APPLICATION FOR IMPROVEMENT PERMIT FOR RESIDENTIAL SITE INDIVIDUAL WATER AND WASTEWATER SYSTEMS PROGRAM

Permit Number: 4116 B

Mecklenburg County
Health Department

SOIL/SITE EVALUATION
for ON-SITE WASTEWATER SYSTEM

PLOT OF SYSTEM

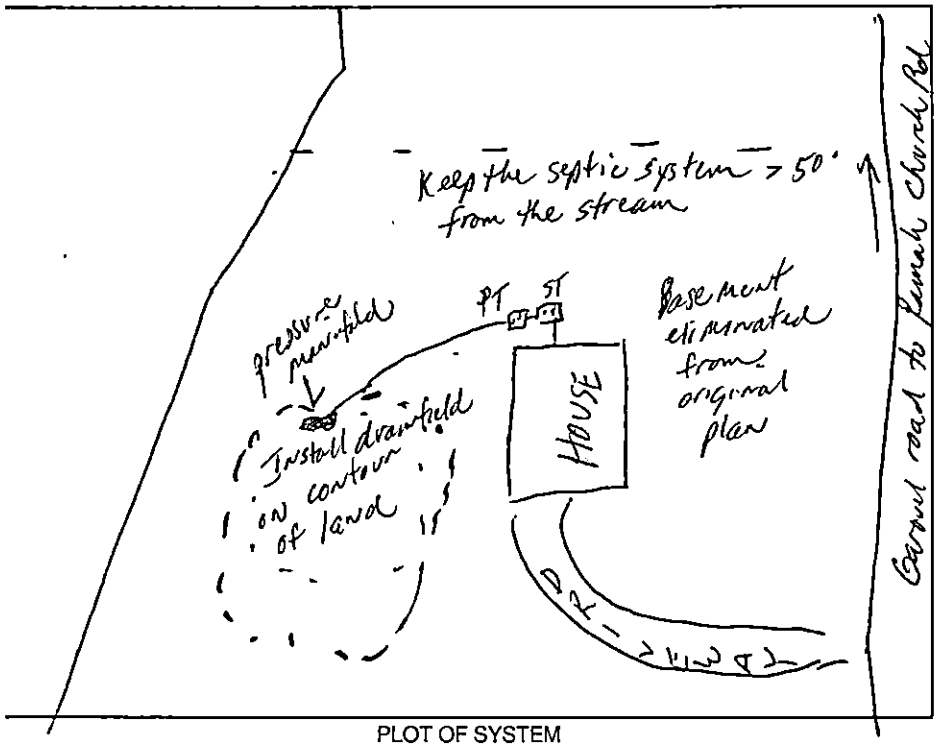
Comments: Install 1500ST, 1000 DT, Pressure Manifold distribution, 4 lines x 86'long x 3'wd x 12"Stone, Install lines appr 36"deep into Saprolite, Keep the septic system >50' from the stream & 100' (50' min) from any wells

PROPOSED PLOT PLAN

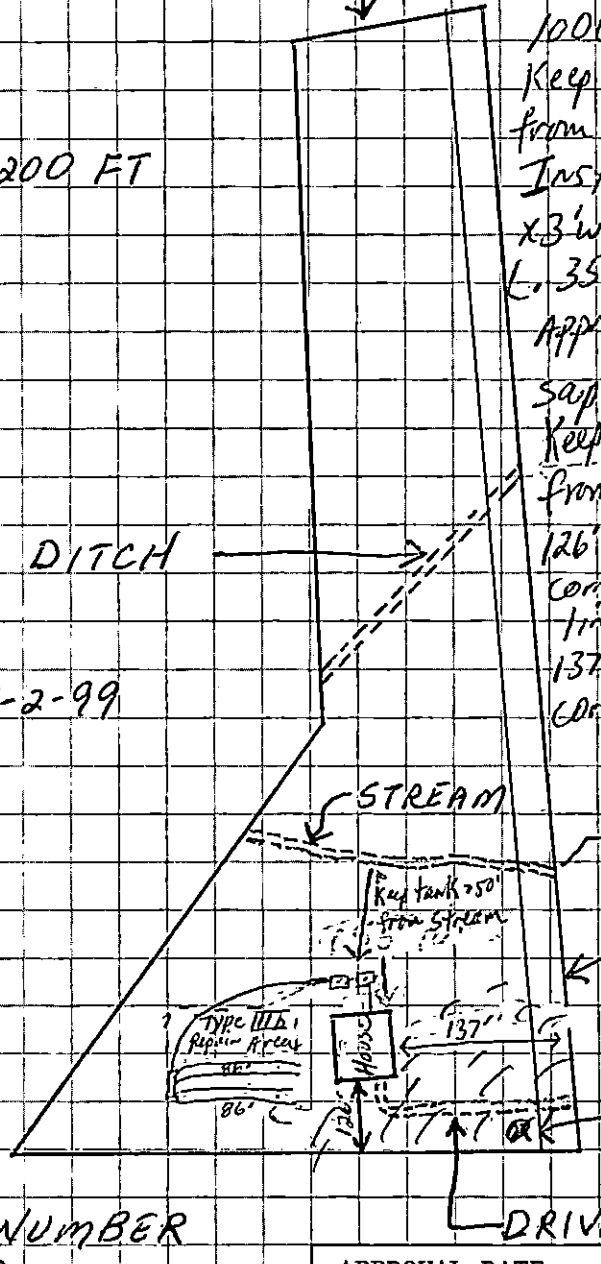
3 Bedroom Residence w/basement
1500 ST Lift pump
1000 DT required
Keep the septic system > 15' from the house foundation
Install 4 lines x 86' long x 3' wd x 12" stone 344 LF (.35 LTAR) Install drainfield Appr. 36" deep into PS saprolite.
Keep the septic system > 50' from the proposed well
126' from the front left house corner the the back property line
137' from the front left house corner to the right property line

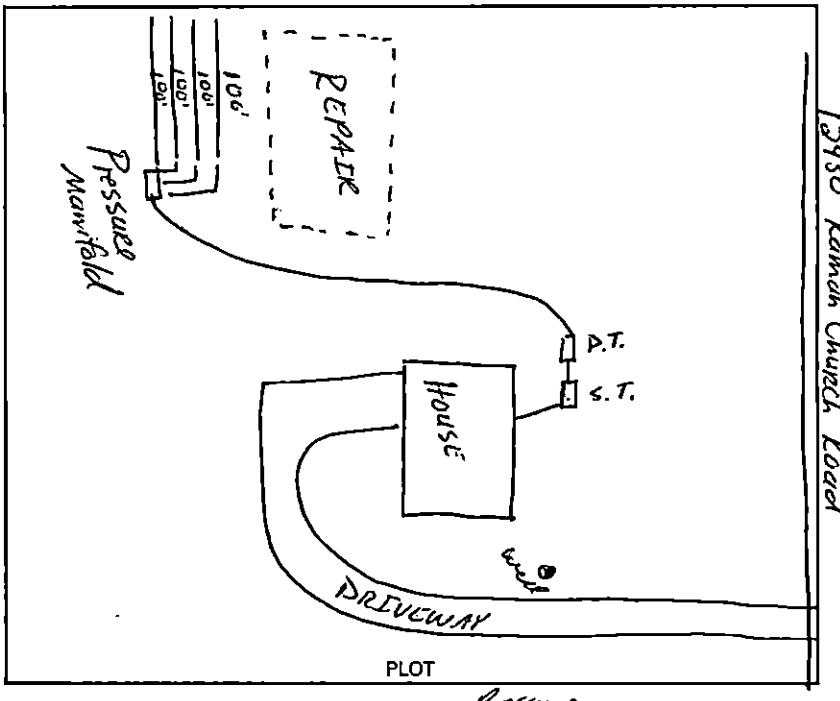
COMMENTS: Three Bedroom Residence

4 lines x 100' x 3' x 12" stone w/ Pressure Manifold

Type III6 pump to Conventional system
